Intel® Xeon™ MP Processor

Specification Update

September 2003

Document Number: 290741-019

System Bus AC Specifications (Reset Conditions)

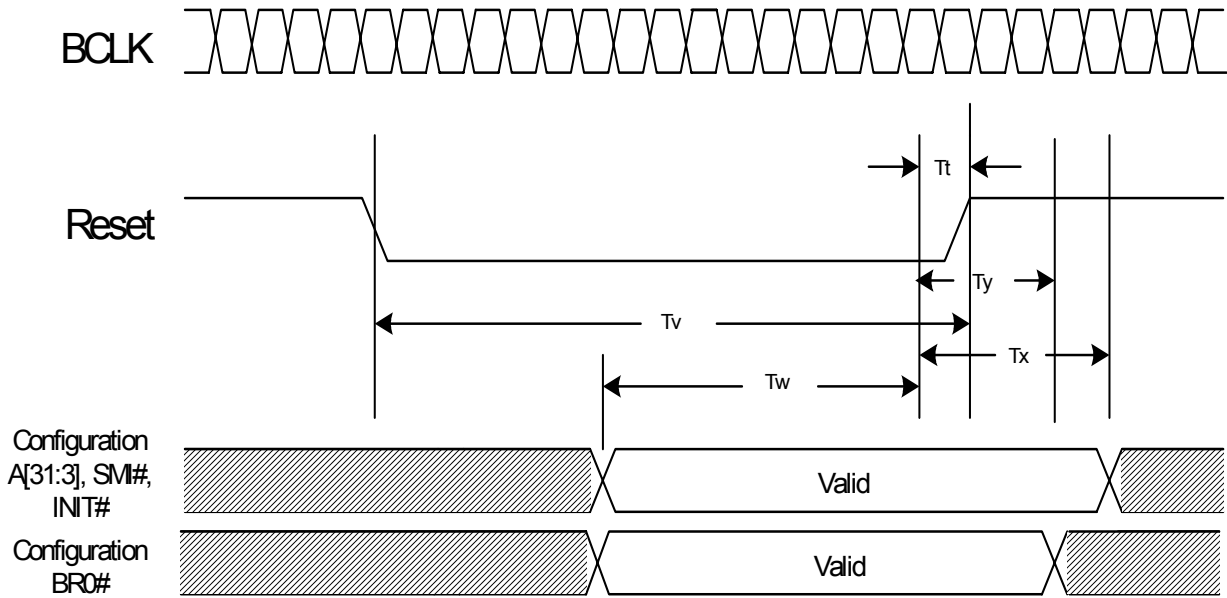
O1: BR0# Maximum Hold Time Specification Change

The BR0# maximum hold time has changed to 2 BCLKs. This change will be shown in the "System Bus AC Specifications (Reset Conditions)" table and "System Bus Reset and Configuration Timings" figure of the above mentioned datasheets. This change will be incorporated in the next revision of the above datasheets.

Signals (A[31:3]#, INIT#, SMI#) Hold Time					
T47: Reset Configuration Signal BR0# Hold Time	2	2	BCLKs	12	2

The following figure will be modified to reflect this change:
